Joystick Piloting Steering Actuator Maintenance

All Joystick Piloting Models

52451

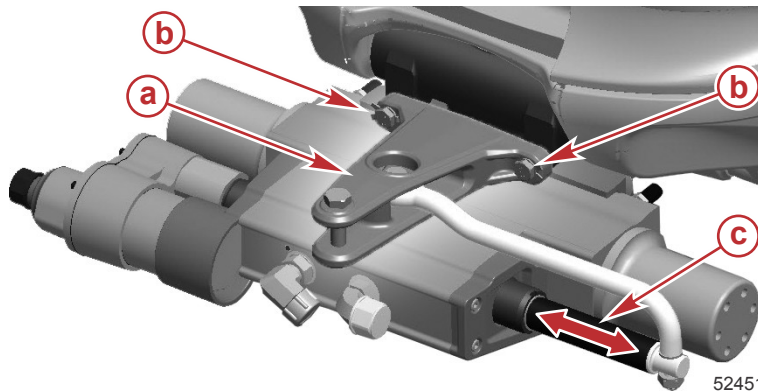
There is no need to apply grease to the Joystick Piloting steering actuator rod during any maintenance activity.

Grease that is applied to the actuator rod may cause the internal seals to lift and pass water into the sealed portion of the actuator. This could potentially lead to internal corrosion that may damage the actuator.

The actuator rod does not require lubrication. Do not apply grease or lubricants to the actuator rod. If grease is present extend the actuator fully and remove the grease. The actuator rod is nickel plated stainless steel and it will not corrode.

IMPORTANT: Do not apply grease or lubricants to the actuator rod.
